Access Compliance Report

Public Rights-of-Way

(Curb Ramps)

Intersection ID: 12482	Main Street: SEAFORTH_DR	Cross Street: SUDBURY_RD	Location: SW
ADA ID: E3CA4607CD08	Ramp Type: BlendTrans1	Initial Pass/Fail: Fail	Overall Compliance: No
Severity Score: 17.5			
Codes/Mitigation Info/Possible Solution		Field Measurements/Component Compliance

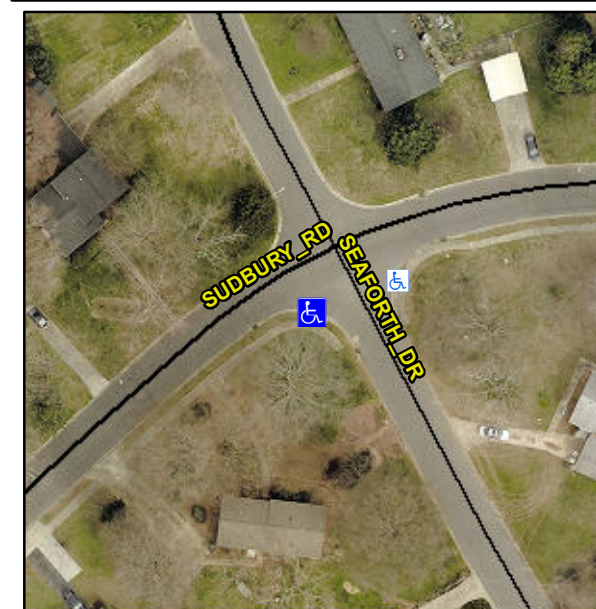
Not Found, R304.5.1

Compliance	Description	Data	Compliance	Description	Data
N/A	Ramp Length (in)	48.5	Yes	BlendTrans Slope (%)	4.4
No	Ramp Width (in)	34.0	Yes	BlendTrans XSlope (%)	0.3
N/A	Flare Type LT	N/A	N/A	Flare Type RT	N/A
N/A	Flare Slope LT (%)	N/A	N/A	Flare Slope RT (%)	N/A
N/A	Flare Traversable LT?	N/A	N/A	Flare Traversable RT?	N/A
N/A	Landing Length (in)	N/A	N/A	DWS Provided?	N/A
N/A	Landing Width (in)	N/A	N/A	DWS Contrast?	N/A
N/A	Landing Slope (%)	N/A	N/A	DWS Length (in)	N/A
N/A	Landing X Slope (%)	N/A	N/A	DWS Full Width?	N/A
N/A	Landing Curb? (Y/N)	N/A	N/A	DWS Offset (in)	N/A
N/A	Shared Landing?	N/A			
N/A	Gutter Ponding?	N/A	N/A	Gutter Slope (%)	N/A
N/A	Gutter Lip Ht (in)	N/A	N/A	Gutter X Slope (%)	N/A
N/A	Painted X Walk1?	No	N/A	Painted X Walk2?	N/A
	X Walk 1 Direction	To NE		X Walk 2 Direction	N/A
	X Walk 1 Width (in)	N/A		X Walk 2 Width (in)	N/A
	X Walk 1 Slope (%)	0.8		X Walk 2 Slope (%)	N/A
	X Walk 1 X Slope (%)	0.9		X Walk 2 X Slope (%)	N/A

N/A	Ramp inside XWalk1?	N/A	N/A	Ramp inside XWalk2?	N/A
	Road Slope (%)	0.9		Clear Space?	N/A
	Road X Slope (%)	0.8	N/A	Clear Space to XWalk (in)	N/A
N/A	Any Obstructions?	N/A	N/A	Storm Grate/Utility Hazard?	N/A
	Obstruction Type			Storm Grate/Utility Type	
		N/A			N/A
			Yes	Surface Condition? (G/P)	Good
			No	Curb Slope (%)	14.6

Remove & Replace Curb Ramp With Two New Directional Ramps or Equivalent.
